United States Department of the Interior

3482
U-50722
(U-065c)

RE: Soldier Canyon Mine Resource Recovery and Protection Plan (R2P2) Modification, Main East Area of the Sunnyside Seam

Enclosure 1
SOLDIER CREEK COAL COMPANY
SOLDIER CANYON MINE
SUNNYSIDE SEAM
MAIN EAST AREA

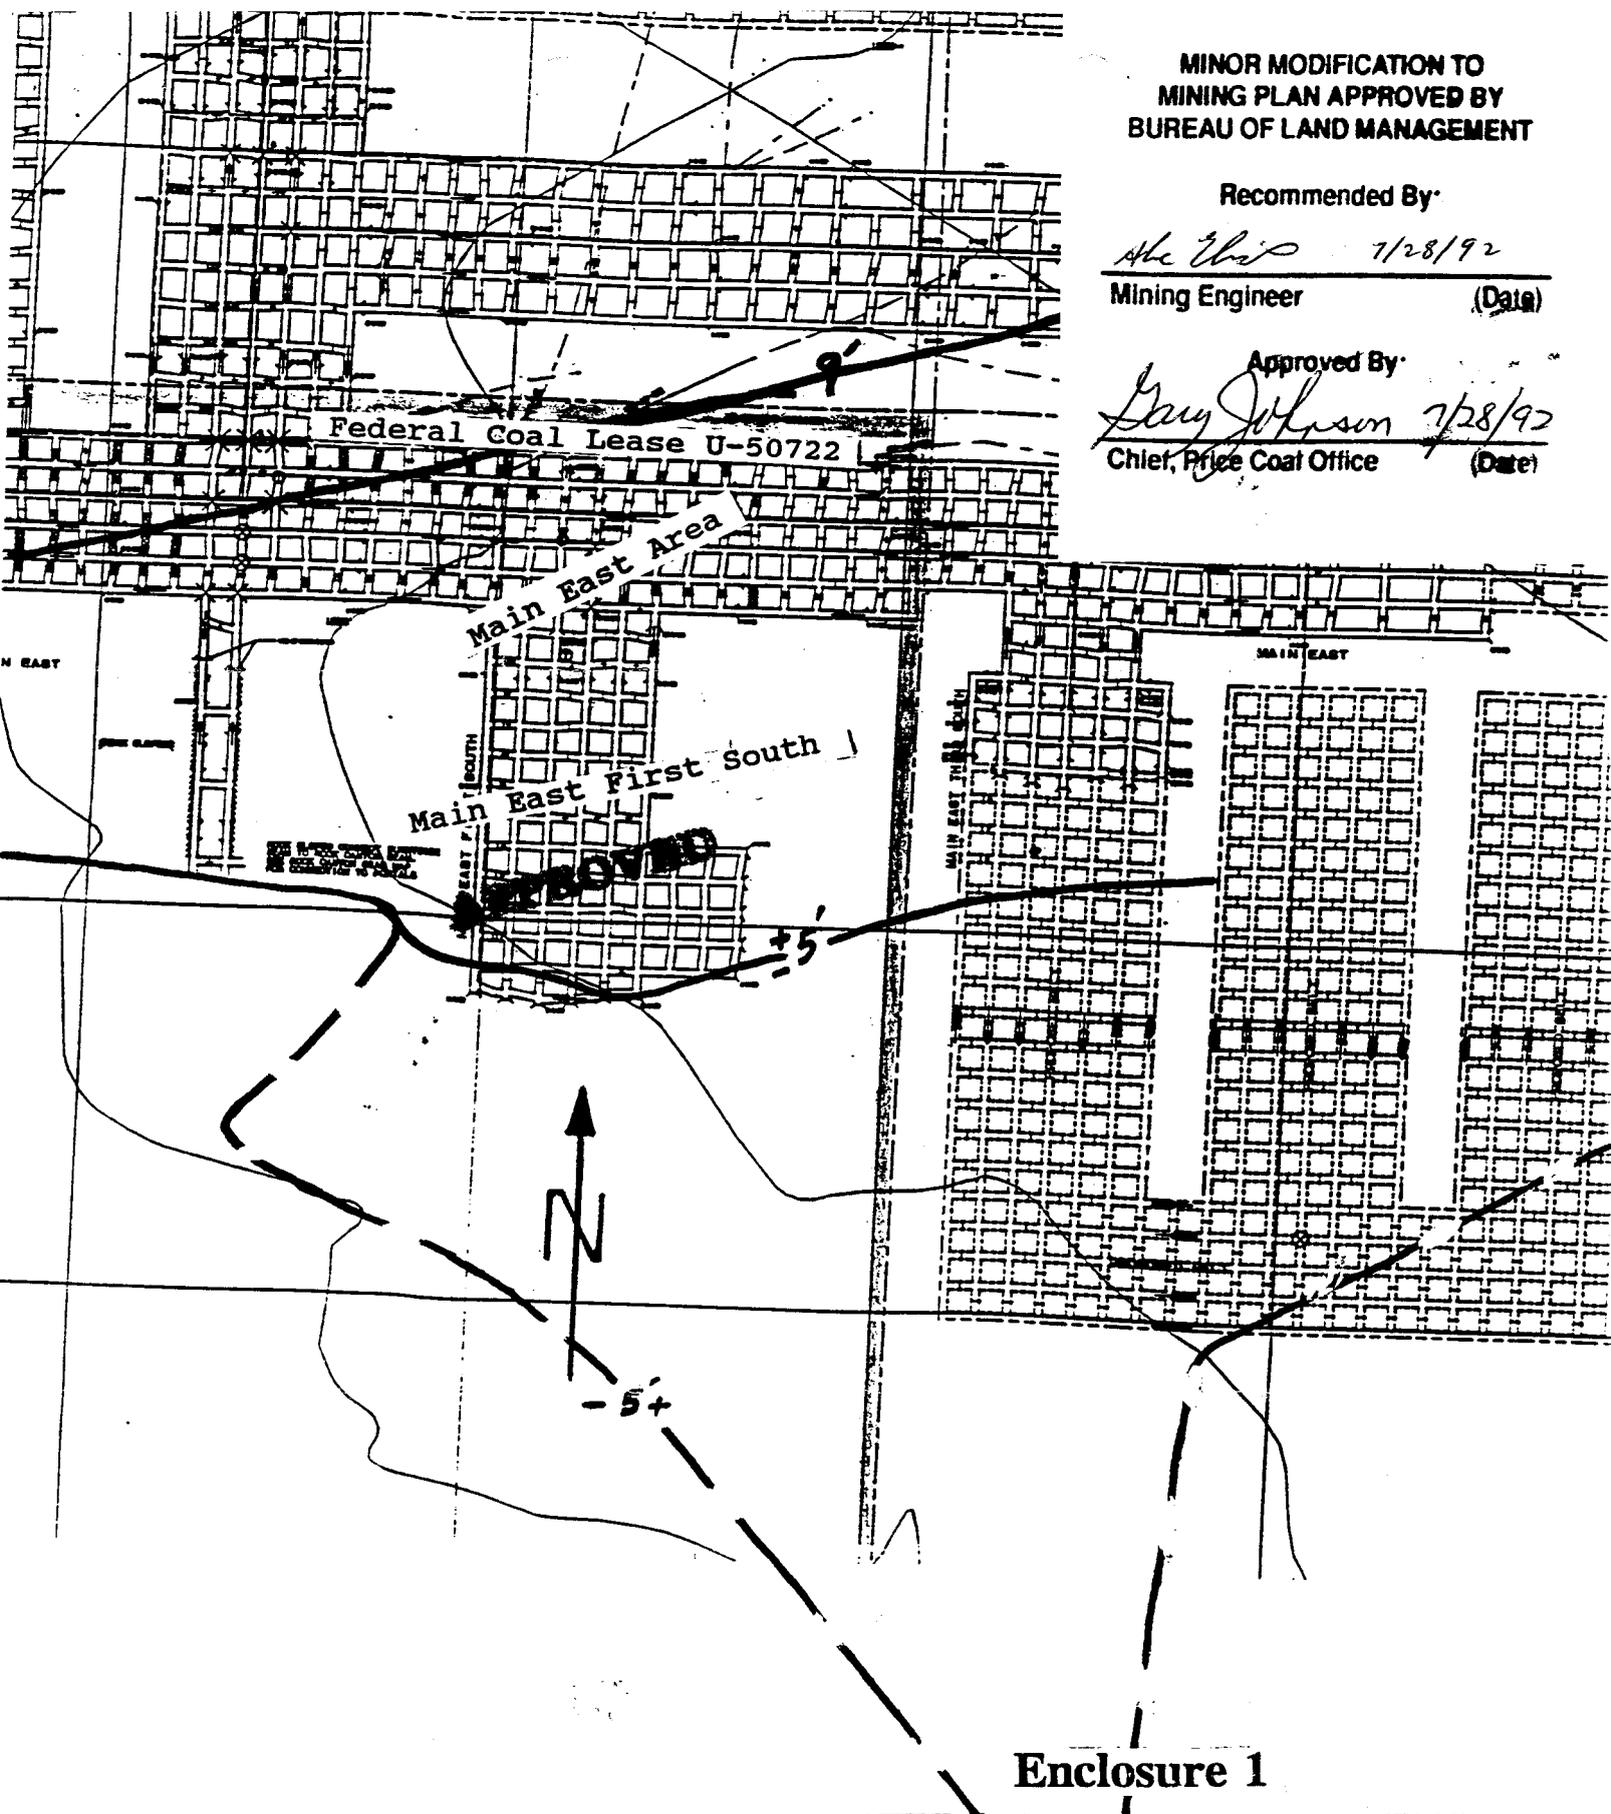
SCCC's approved mining plan was to recover the developed pillars in the Main East area of the Sunnyside Seam (see enclosure 1), then recover the previously developed pillars in the underlying Rock Canyon Seam (see enclosure 2). Soldier Creek is now proposing to change this plan and begin pillar retreat mining in the Fifth East area of the Rock Canyon Seam. Recovery of the pillars in the Sunnyside Seam will be delayed and addressed appropriately in future mine planning. The company is in the market for sale and any future mine plan changes will depend on the new buyer.

The extent of pillar development and the conditions of the pertinent sections in each seam were witnessed by Abe Elias, mining engineer, during an inspection conducted on July 14, 1992. Development of the Main East First South section was discontinued at crosscut #13 because the coal thinned to less than 5 feet. Conditions were stable but a weak roof, rib sloughage, and a void between the roof and coal were observed. Full development had occurred in the Fifth and Sixth North sections of the Rock Canyon Seam. These sections were in excellent condition with a roof consisting of a competent silty shale. No indication of weak zones, roof fractures, or rib sloughage were present.

By overlaying the maps of the two seams, the BLM has verified that the Main East First South section of the Sunnyside Seam is located approximately over the center of the underlying Fifth East area of the Rock Canyon Seam. An analysis of available drill logs shows an average interburden of 145 feet between the seams with a sandstone content of 53 percent in this area of the mine.

1. The Sunnyside Seam will not be mined for at least 6 months after the Rock Canyon Seam is mined to allow for the strata to stabilize.
2. SCCC must submit a modified plan for mining the Main East area in the Sunnyside Seam within six months.

SOLDIER CREEK COAL COMPANY
SOLDIER CANYON MINE
ROCK CANYON SEAM
FIFTH EAST AREA

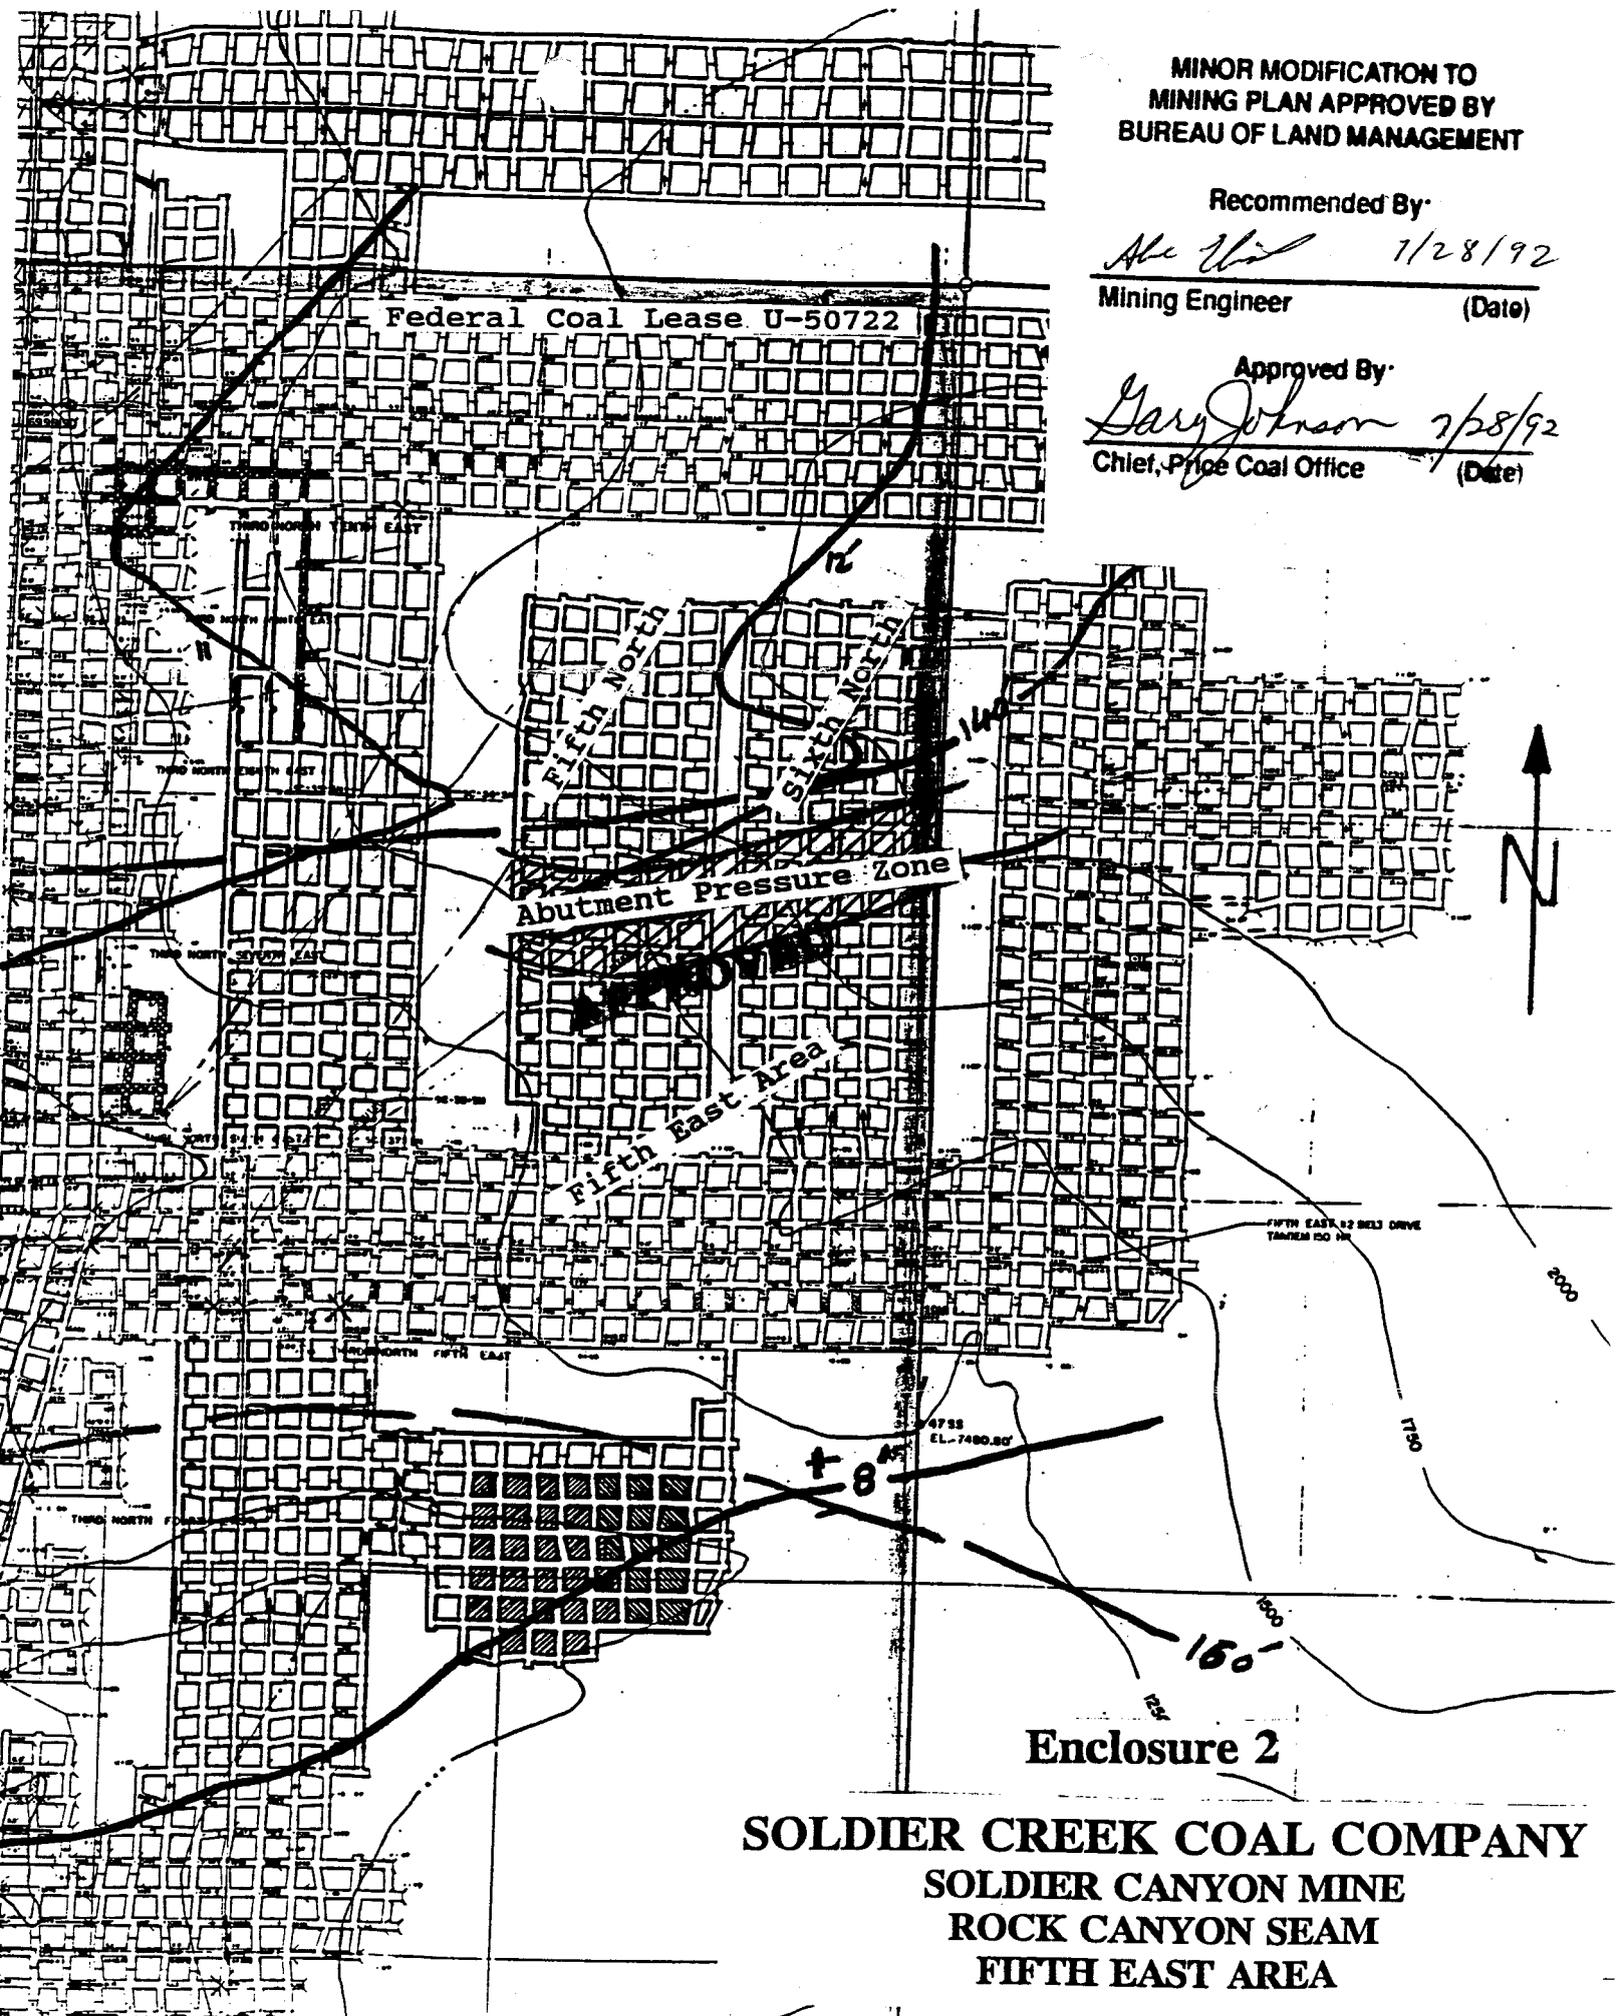
According to SCCC, pillaring the Sunnyside Seam first would transfer abutment pressures into the center of the underlying Fifth East area of the Rock Canyon Seam causing a significant loss of coal reserves (see enclosure 2). The interburden, which is approximately 150 feet thick and contains over 40 feet of sandstone, is expected to minimize any adverse affects on the Sunnyside Seam by mining the underlying Rock Canyon Seam in advance.

Our analysis indicates that pillaring of the Sunnyside Seam, prior to the Rock Canyon Seam, will transmit abutment pressures to the Rock Canyon Seam. This could impact the recovery of an estimated 43,000 tons of Federal coal in the Rock Canyon Seam. Conversely, the thickness and sandstone content of the interburden should prevent adverse impacts to the Sunnyside Seam induced by undermining of the Rock Canyon Seam. This could enhance the overall recovery of both seams. The potential for the migration of methane from the Rock Canyon Seam to the Sunnyside Seam due to fracturing should be very negligible due to the degasification program currently in operation in the mine.
